Office Action Summary

10/061,458

DINH ET AL.

DETAILED ACTION

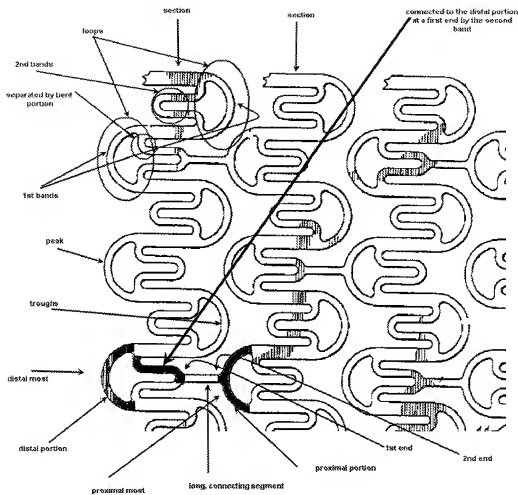
Claims 25-33 are rejected under 35 U.S.C. 102(e) as being anticipated by Allen et al US Patent Pub. 2001/0016770.

Allen et al discloses a stent having serpentine circumferential bands connected one to the other, the bands include first serpentine circumferential bands (58) and second serpentine circumferential bands (3). The first and second bands are connected by a plurality of longitudinal connectors (50).

Regarding claims 25-27, see Figure below.

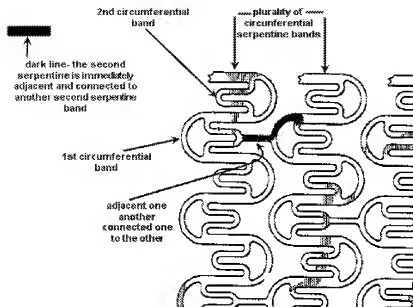
Regarding claims 28-33, see figure below in order to clarify how the Examiner interpreted the claims. With respect to the language: “at least one second serpentine circumferential band immediately adjacent to and connected to another second serpentine circumferential band by a longitudinal connector”, the examiner interpreted the claims as follow: the at least one second serpentine band is immediately adjacent to and connected to another band by connector 50 and by the first circumferential band. Every first serpentine

circumferential band being adjacent to a second serpentine circumferential band and every second serpentine circumferential band being adjacent to a first serpentine circumferential band.

Wherein the first bend and the second bend are oriented to the same direction and pointing away from the cell.
